**TOWN OF FAIRFAX
STAFF REPORT
Department of Planning and Building Services**

TO: Fairfax Planning Commission
DATE: May 21, 2015
FROM: Jim Moore, Director of Planning and Building Services
Linda Neal, Principal Planner
LOCATION: 188 Bothin Road; Assessor's Parcel No. 001-082-56
ZONING: Residential Single-family RS 6 Zone District
PROJECT: Addition/remodel of a single-family residence
ACTION: Hill Area Residential Development Permit and Combined Side Setback Variance; Application # 15-14
APPLICANT: Ted Arleo, Architect
OWNER: Cheryl Tatum
CEQA STATUS: 15301(e)(1) and 15305(a)

188 BOTHIN ROAD

FIGURE: 2

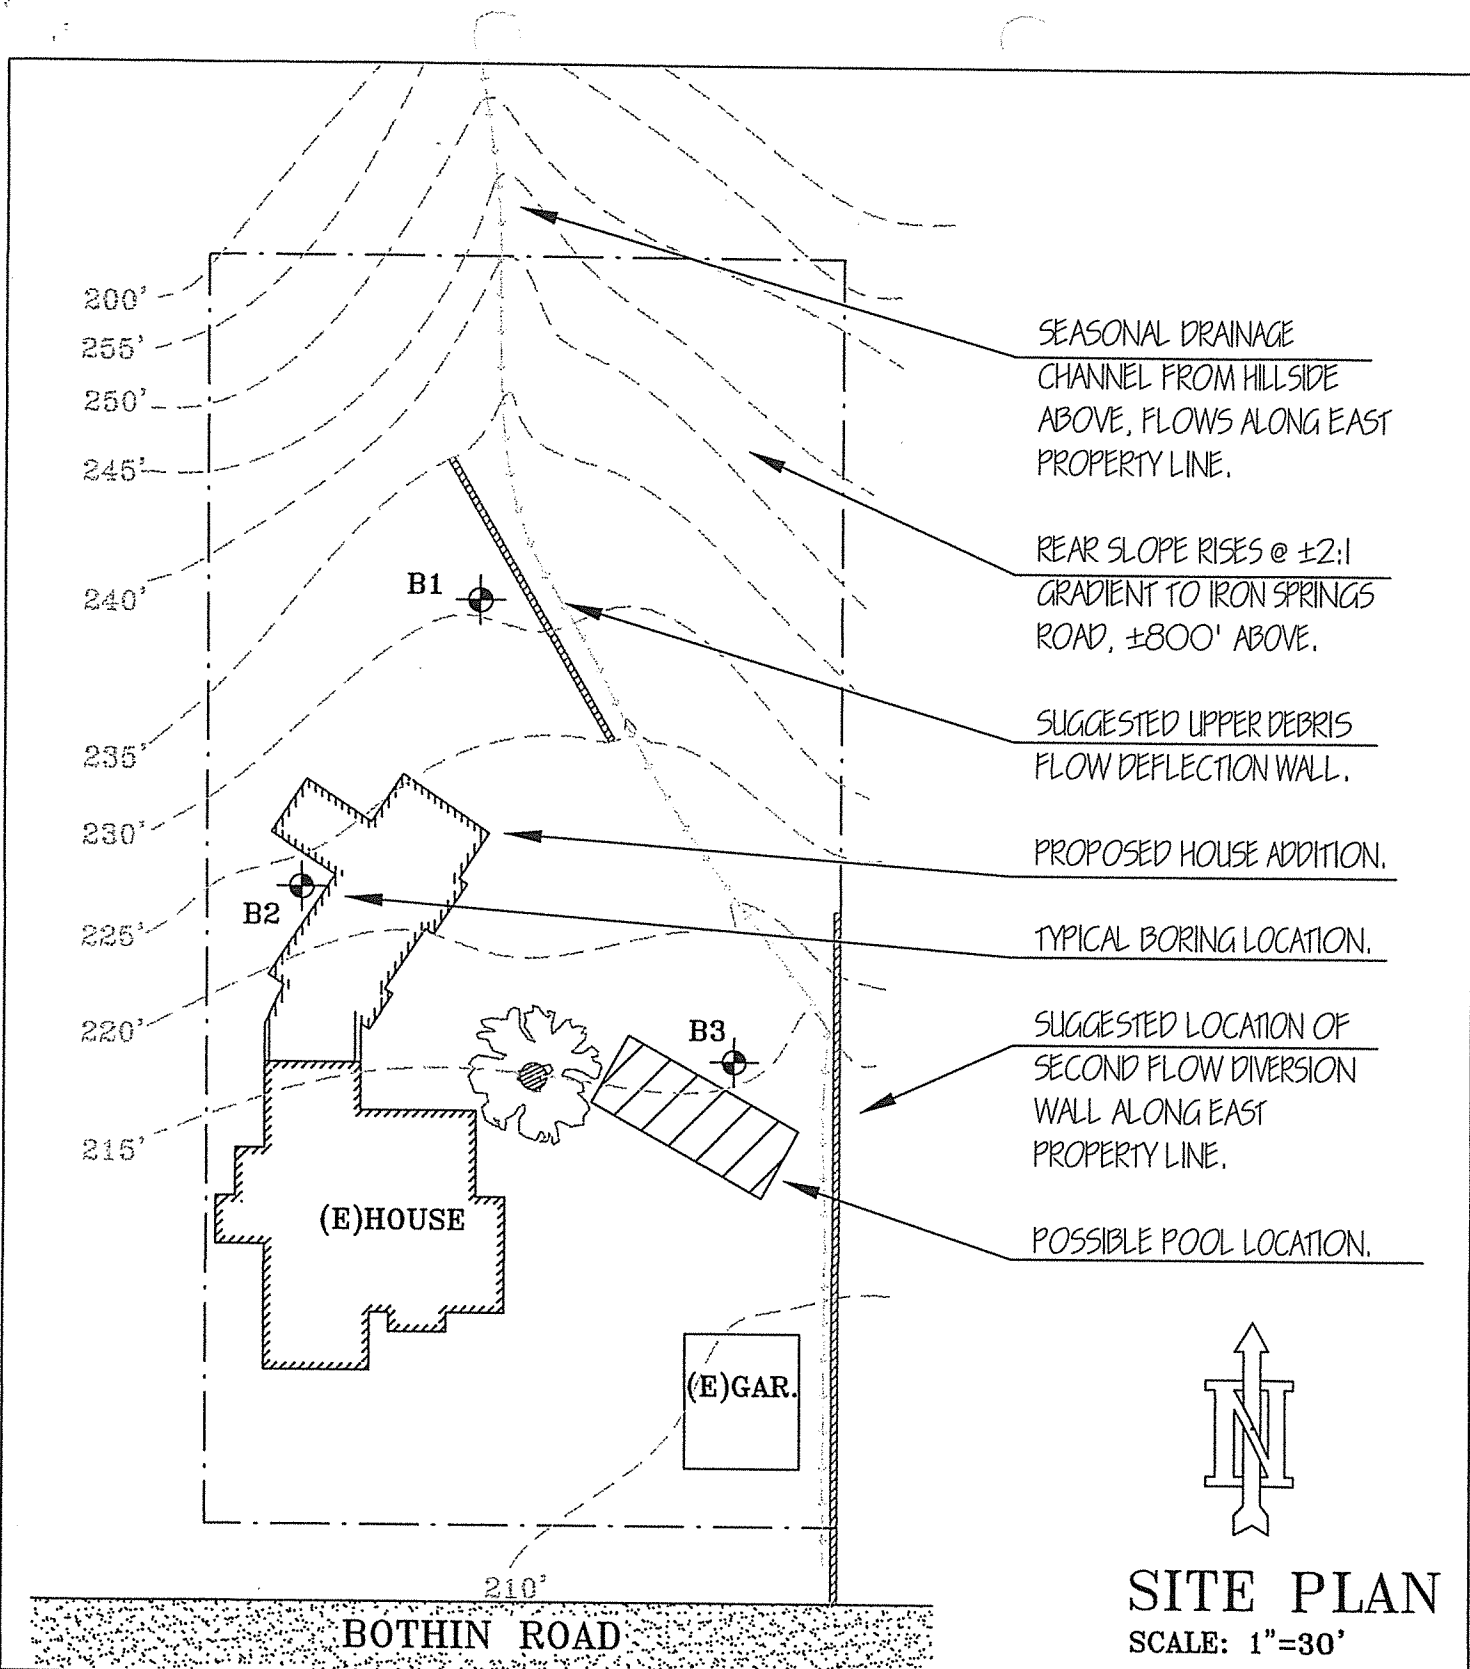
3. Figure 2 in the geotechnical report shows approximately a 50 foot debris wall at the center of the site but the plan only shows a 35 foot wall. The geotechnical engineer must indicate in writing that the wall as shown satisfies his requirements. ~~Drawing C-2 has been updated to show the wall to be consistent with the revised geotechnical report.~~ **SEE DAVE OLVES LETTER DATED 3/24/15**
